**BOARD OF ZONING ADJUSTMENT
STAFF REPORT****Date: April 4, 2011****CASE NUMBER**

5667

Renania Gipson

LOCATION6795 & 6885 Simpson Road
(Northern terminus of Simpson Road [private street])**VARIANCE REQUEST****USE:** Mobile home park**PARKING & MANEUVERING:** No defined parking or accessways**SURFACING:** Gravel driveway**LANDSCAPING & TREE PLANTINGS:** No landscaping areas**BUFFER:** No buffers in an R-1, Single-Family Residential District**ZONING ORDINANCE
REQUIREMENT****USE:** Minimum of R-3, Multiple-Family Residential District zoning with Planning Approval for a mobile home park.**PARKING & MANEUVERING:** 1.5 designated parking spaces per dwelling unit, and designated accessways of sufficient width.**SURFACING:** Parking and accessways surfaced with concrete or asphalt.**LANDSCAPING & TREE PLANTINGS:** One overstory tree/30 linear feet of road frontage, one tree per 30-linear feet of perimeter/ at least half must be of the overstory type and one understory tree/required parking space.**BUFFER:** A buffer between commercial and residential properties.**ZONING**

SITE PLAN

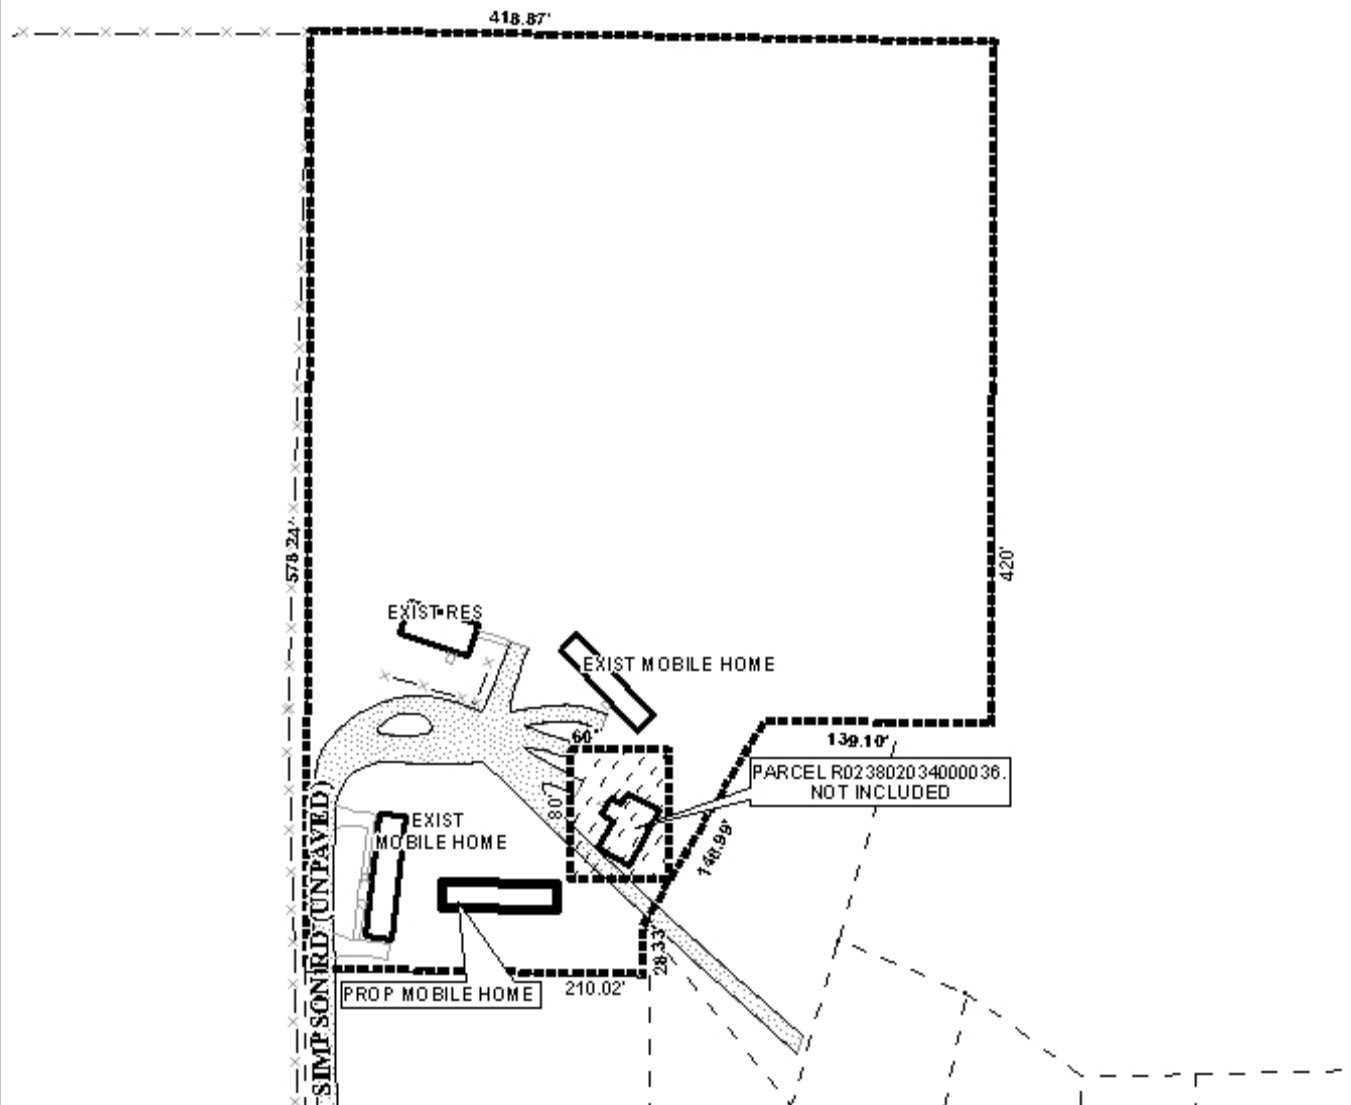
The submitted site plan shows that the site has a gravel drive providing access to the existing residences that is part of Simpson Road, a private road. Section 64-6.A.3.a. of the Zoning Ordinance requires that all accessways and parking be paved with asphalt or concrete. As an existing private road, the applicant should not be required to improve Simpson Road.

Section 64-6.A.6. of the Zoning Ordinance requires that multiple-family dwellings provide at least 1.5 parking spaces per dwelling unit. The proposed additional trailer would mean the mobile home park is required to provide a minimum of 6 parking spaces. The submitted site plan shows that currently there are two concrete driveways that are each large enough to constitute one parking space each. This means that there is a shortage of 4 defined parking spaces. It should also be noted that there is no defined accessway to the newly proposed trailer. Parking in the form of a parking pad made of gravel to match Simpson Road that would be large enough for two cars should be placed between Simpson Road and the proposed dwelling to increase available parking as well as provide an accessway to the trailer.

There are no landscaping areas proposed to be placed at the site. However, it should be noted that with the exception of the Southwest corner of the property where the residences are located that the rest of the property appears to be an undisturbed wooded area. According to landscaping requirements in Section 64-4.E.3. of the Zoning Ordinance, the site would be required to plant frontage trees, perimeter trees, and trees for parking. The site's access to Simpson Road (a private road) is through prescriptive easements, and therefore determination of proper rights-of-way may be difficult. Because the submitted site plan does not show any existing trees that would qualify for tree credits, it is not possible to determine if the existing trees on the property would fulfill these planting requirements.

Also, if the mobile home park use is allowed, a buffer between the site and adjacent residential properties would be required by Section 64-4.D.1. of the Zoning Ordinance. The site has one residential property to the South, one residential property to the Southeast, and one residential property to the East, with a school in an R-1 district to the West. As mentioned previously, portions of the parcel are heavily wooded, and would fulfill any buffer requirement of the property.

It should be noted that Chapter 37 of the Mobile City Code sets out several design requirements for mobile home parks, and, as this application meets the definition of a mobile home park, the provisions of Chapter 37 could apply. Specifically, the site plan would need to show the following:

- Section 37-56: a playground common area surrounded by a fence or a wall of at least 4 feet in height containing 150 square feet for each mobile home lot
- Section 37-57: a dedicated patio area of at least 180 square feet on each lot, surfaced with rigid impervious pavement

It should also be noted that a discrepancy was found in the location of the smaller parcel (R023802034000036.) enclosed by the parcel (R023802034000034.) that these variances are requested for. Tax records show the enclosed parcel to be 31.5'± East of the larger parcel's Western property line, whereas the property deeds show the enclosed parcel 165'± East of the larger parcel's Western property line. It is also of note that the legal description of the enclosed parcel in the 2009 deed describes a polygon that does not close. The site plan submitted reflects the deed described location, and after discussion with the surveyor, a letter was submitted stating that a scrivener's error occurred in the writing of the deed and after examining physical and parol evidence it was determined that the survey does indeed reflect the appropriate location for the enclosed parcel. The smaller enclosed parcel was created by 1967 before the site was in the City of Mobile or the planning jurisdiction.

- 1) the residences on the property be limited to family members only;
- 2) all necessary building, electrical, and plumbing permits are obtained;
- 3) parking pad sufficient for two cars surfaced with either gravel, asphalt, or concrete be provided off Simpson Road at new dwelling; and
- 4) revised legal description of the enclosed parcel (R023802034000036.) to describe a closed polygon.
